TECHNICAL MEMORANDUM

Project No. CA-GLD-1791470A

RESPONSES TO ABOUD AND ASSOCIATES INC. / TOWNSHIP OF PUSLINCH REVIEW COMMENTS – PROPOSED CBM ABERFOYLE SOUTH LAKE PIT

The table below provides WSP's responses to review comments made by Aboud and Associates Inc. (Aboud) on February 8, 2024, related to the ARA licence application for the proposed CBM Aberfoyle South Lake Pit.

**Headwater Drainage Feature
Mapping**

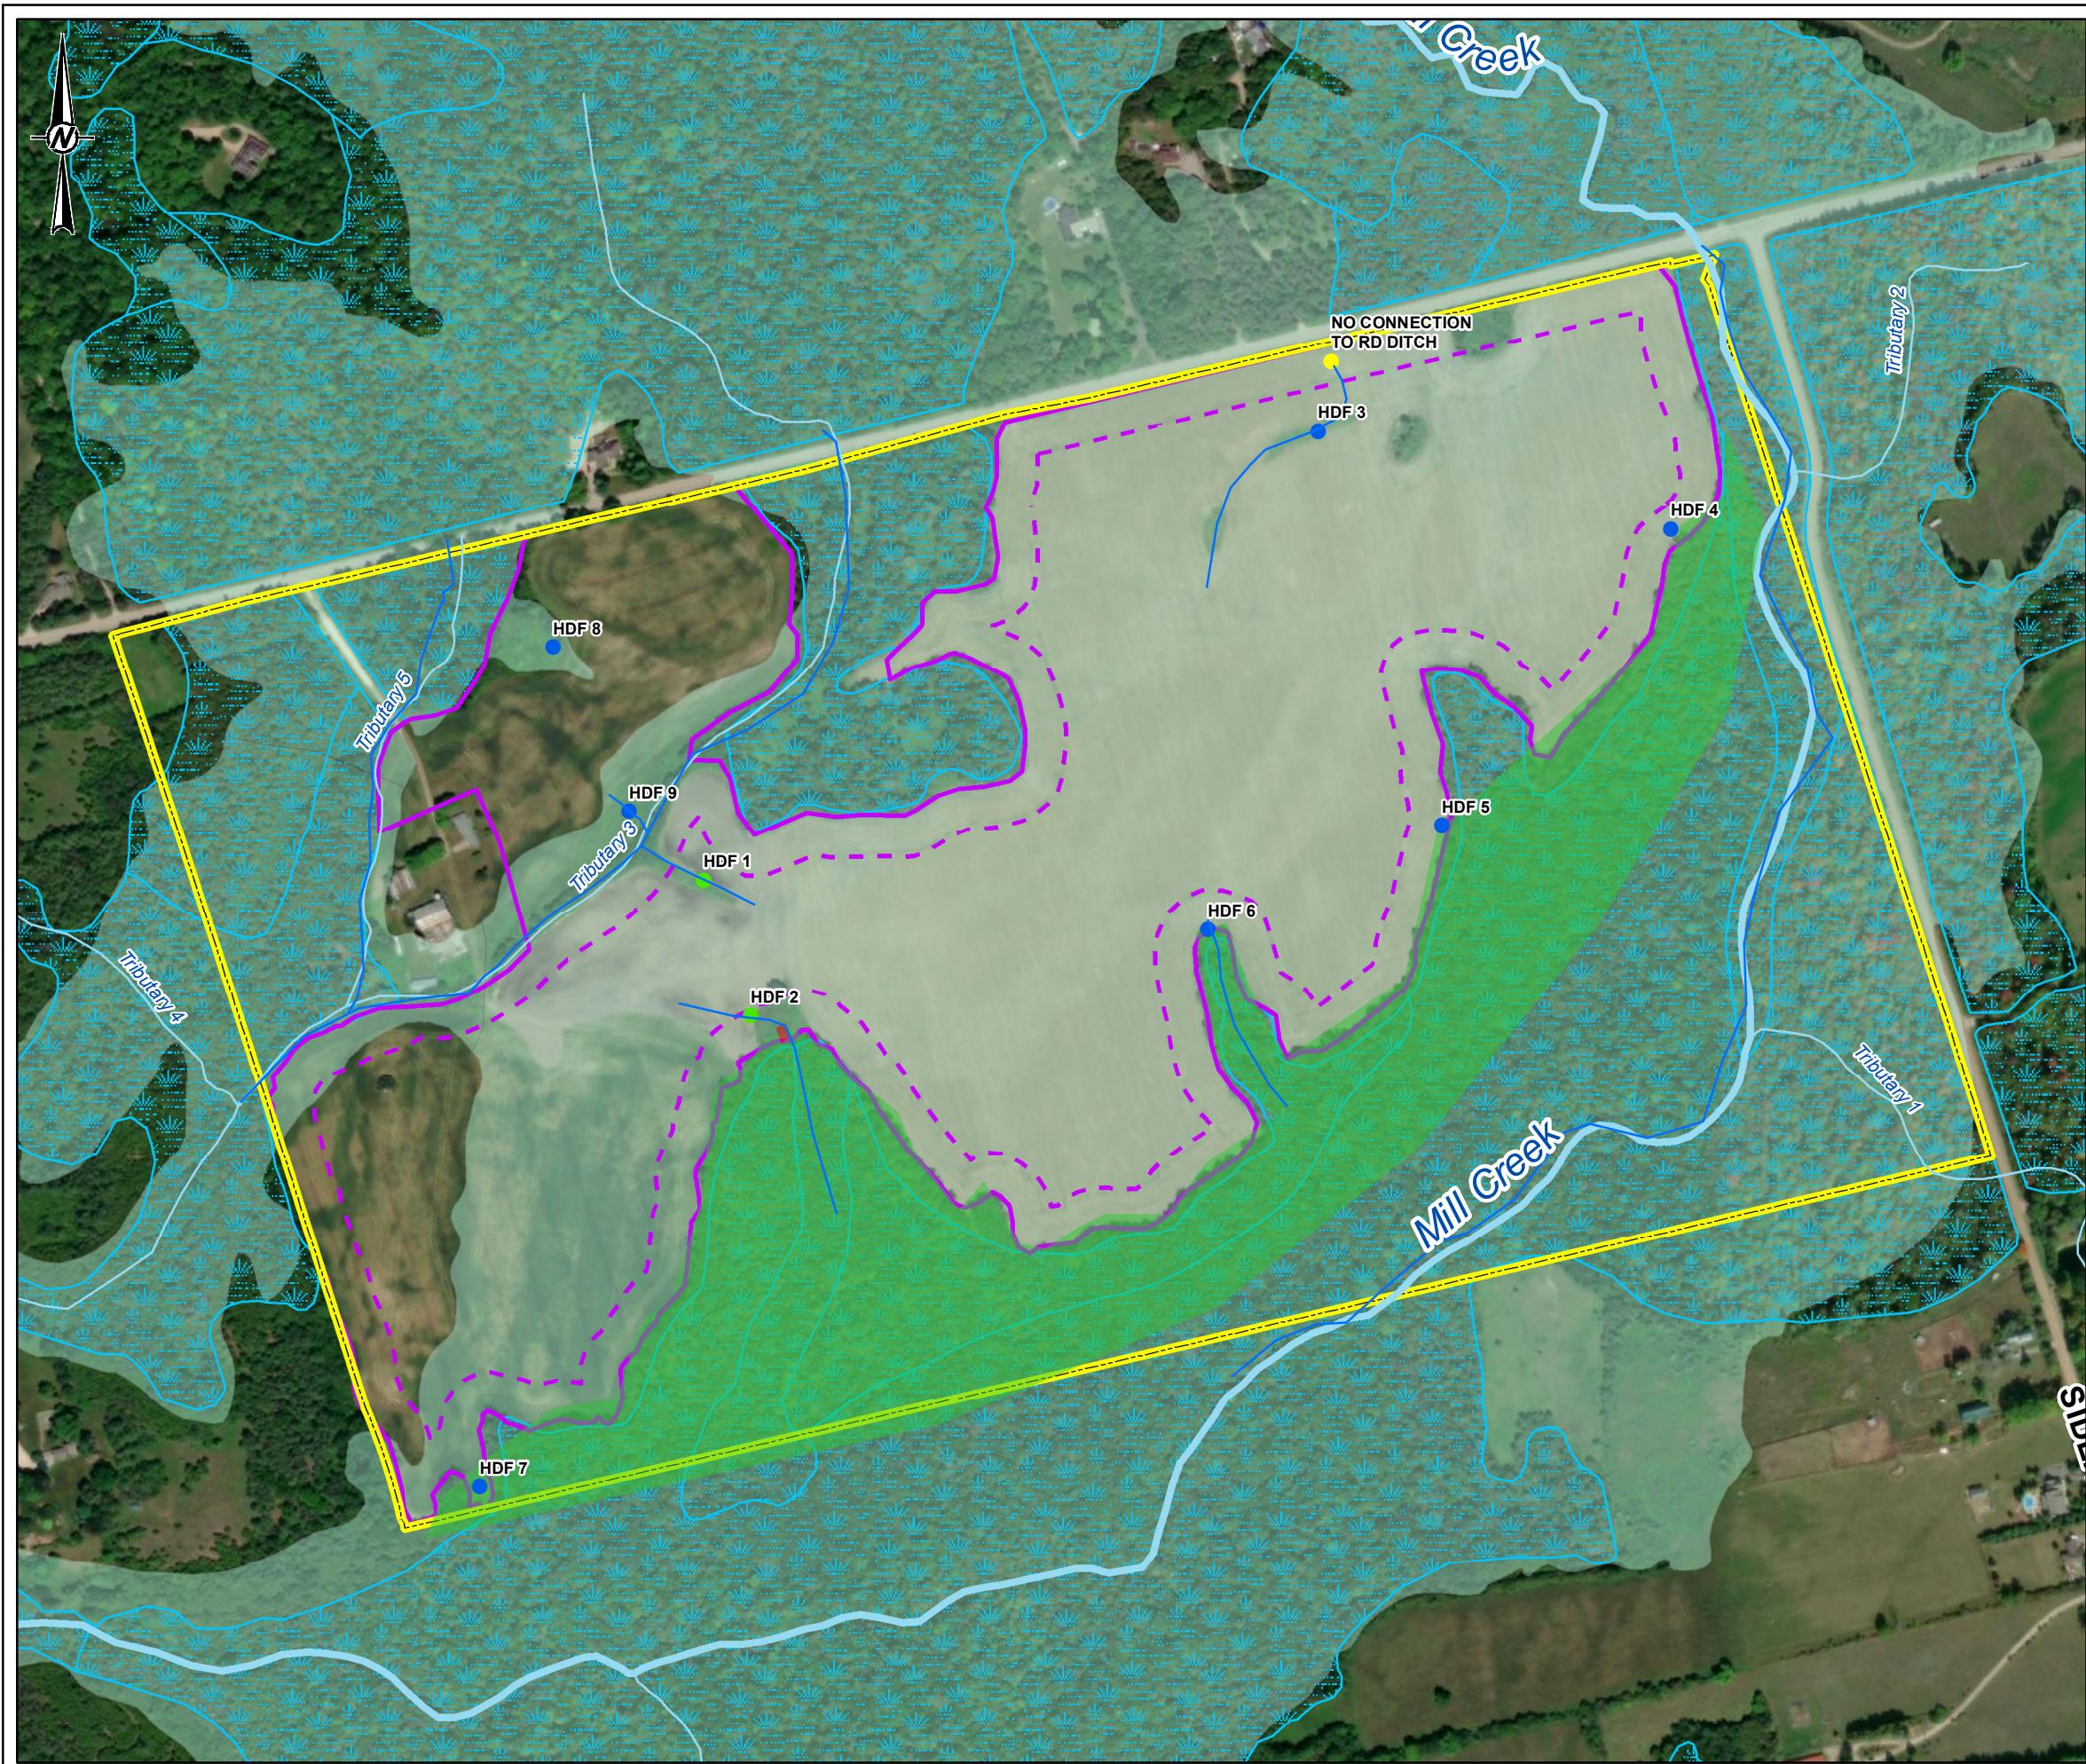
Num	Topic	Section	Aboud Comment	WSP Response
12	Natural Environment	General	<p>Per AA's Pre Consultation Peer Review, headwater drainage feature assessments were required for the site, these surveys are not identified or discussed in the report. This survey is particularly important to determine the regime for tributary 3 as well as to identify any HDF's that occur within the agricultural areas.</p>	<p>It should be noted that Tributary #3 has been referred to as both intermittent and perennial within the different existing conditions reports. The reference to the seasonality of the stream has been based on the fact that the installed loggers have measured zero flow on at least four occasions, while during these periods, pooled water was still present. Further to this, the water depth during these low flow periods is likely limiting to fish as during summer, there is insufficient baseflow to consistently sustain water in Tributary #3. Additional information is provided in the attached Fish Community Assessment. Therefore, referring to Tributary #3 as intermittent is appropriate when considering fish habitat.</p> <p>Per the Evaluation, Classification and Management of Headwater Drainage Features Guidelines (TRCA & CVC 2014), pre-consultation with the Conservation Authority is recommended to determine scope and identify gaps with respect to the need for a Headwater Drainage Feature (HDF) Assessment. GRCA reviewed and provided comments on the Terms of Reference in November 2021 and did not identify the need for a HDF assessment. As such, it was not included in the field survey scope. Subsequently, in response to Aboud's comment, a HDF Assessment has been undertaken. The site visits were completed in August 2024, March 2025 and May 2025 in accordance with the abovementioned guideline (TRCA & CVC 2014) and Section 4, Module 11 for Unconstrained Headwater Sampling of the Ontario Stream Assessment Protocol (MNRF Version 10, 2017). Potential HDFs, drainage patterns and linkages between the site and watercourses (i.e. Tributary 3, Tributary 5 & Mill Creek) were identified. Nine areas were identified as having potential HDF (Attachment 3):</p>

Num	Topic	Section	Aboud Comment	WSP Response
				<ul style="list-style-type: none"> ▪ Of the nine potential HDFs, seven (HDF 3 to HDF9) were dry or only contained stagnant water in the spring assessment and were all dry in the summer assessment. ▪ It was observed that the remaining two features (HDF1 and HDF2) provided some movement of water off the property and were moved forward through the unconstrained HDF assessment. <p>Based on the assessment, drainage segments HDF1 and HDF2 were assessed at the <i>Maintain Recharge</i>, while the seven remaining drainage segments were assessed as <i>No Mitigation Required</i>.</p> <p>The following recommended management, outlined by the HDF Guidelines (TRCA and CVC, 2014), are in place for Maintain Recharge of HDFs on site:</p> <ul style="list-style-type: none"> ▪ Maintain overall water balance by implementing mitigation measures to promote infiltration of rainwater runoff. <p>It should also be noted that, due to the implementation of O.Reg.41/24, HDF are no longer under the jurisdiction of Conservation Authorities, and further, Conservation Authority policies are not applicable to applications under the ARA, which do not require permits or approvals from Conservation Authorities.</p>

The HDFs assessed on the subject property were mapped on an aerial photography base, shown on Figure 1 in Appendix A – *Headwater Drainage Feature Assessment Mapping*.

Study Area - Associated Watercourses

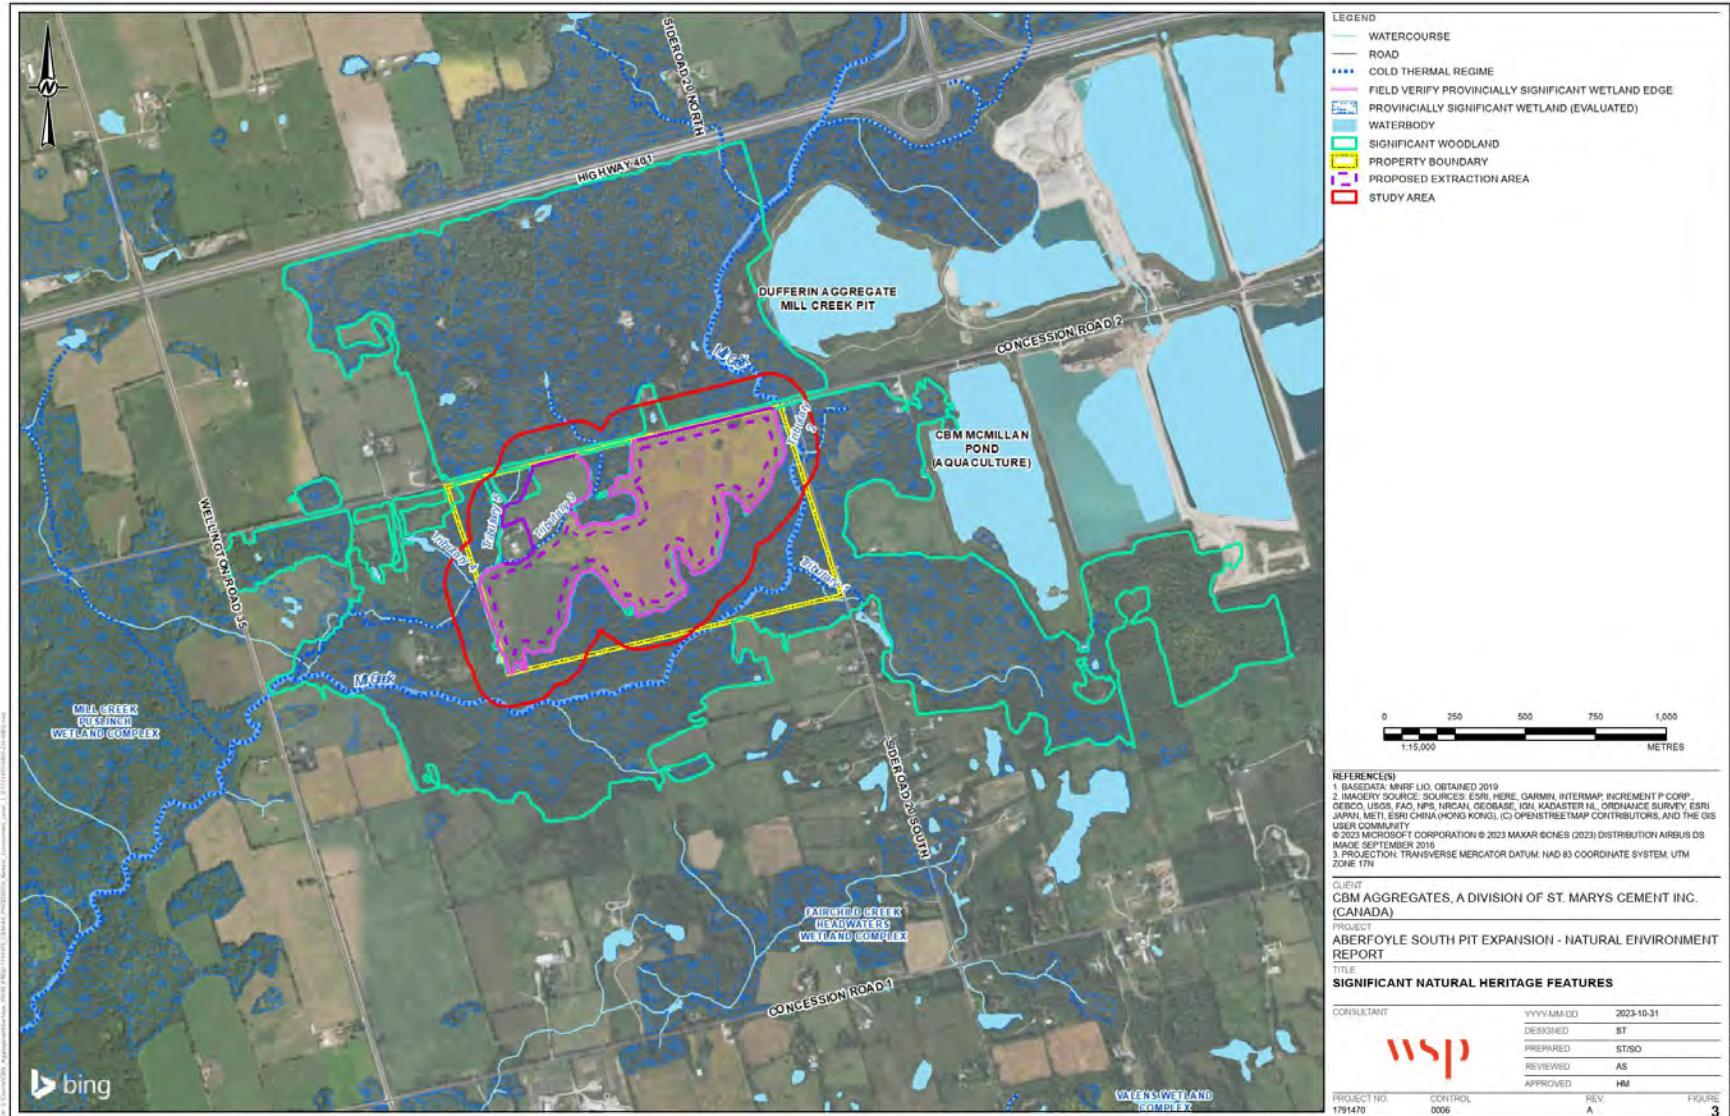
Num	Topic	Section	Aboud Comment	WSP Response
13	Natural Environment	General	Per AA's Pre Consultation Peer Review, Fish Community Sampling was required for the on-site watercourses to determine species present, these surveys were not identified or discussed in the report.	<p>A fish community survey was undertaken in September 2024, and the assessment is provided in Attachment 2. The findings of the fish community survey support what is reported in Section 5.6.4 of the NER.</p> <p>Tributary #3 was classified as fish habitat with assumed similar species assemblage as Mill Creek. This classification was in line with MNR records and observations of small-bodied fish within Tributary #3. The assessment in the NER took into account that Tributary #3 is fish habitat. The Mill Creek is frequently sampled with current data available.</p> <p>The Project was submitted for DFO review to assess the potential of the Project to result in 'death of fish' and/or 'harmful alteration, disruption or destruction of fish habitat' (HADD).</p> <p>Ongoing consultation with DFO is underway. DFO are reviewing the water reports as well as the supplementary technical memoranda, which include all Tributaries as well as Mill Creek.</p>

There are five unnamed tributaries to Mill Creek associated with the Site. The following four unnamed tributaries (excluding Tributary #3) lie outside of the licence boundary, as seen on the figure attached (APPENDIX A).
